Service Bulletin

Bulletin No.: 17-NA-151

Subject: Outside Noise Heard from Back of Cab

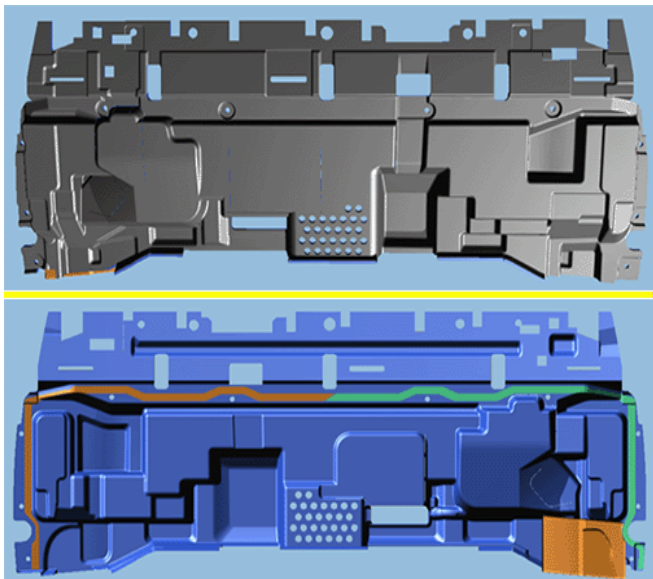
Involved Region or Country	North America and N.A. Export Regions
Condition	Some customers may comment on hearing outside noise from the back of vehicle cab.
Cause	The cause of the condition may be a window of vehicle builds involved a cab insulator supplier change in which a 2D design was installed which didn't comply with previous 3D insulator acoustic performance.
Correction	Inspect the vehicle's rear cab insulator to verify which design it currently has and continue to the repair recommendation in the Service Procedure below.

Inspect the rear cab insulator to verify which insulator the vehicle contains:

Note: Replacement of the insulator should only be performed on vehicles that fall between the breakpoints noted above.

- If the vehicle contains the **3D** insulator shown in the front and rear view examples above, **DO NOT** replace the insulator. No further repairs are recommended.
- If the vehicle contains the **2D** insulator shown in the front and rear view examples above, acoustic performance can be gained by replacing the insulator with the **3D** design. Replace the body rear panel insulator. Refer to *Body Rear Panel Insulator Replacement* in SI.
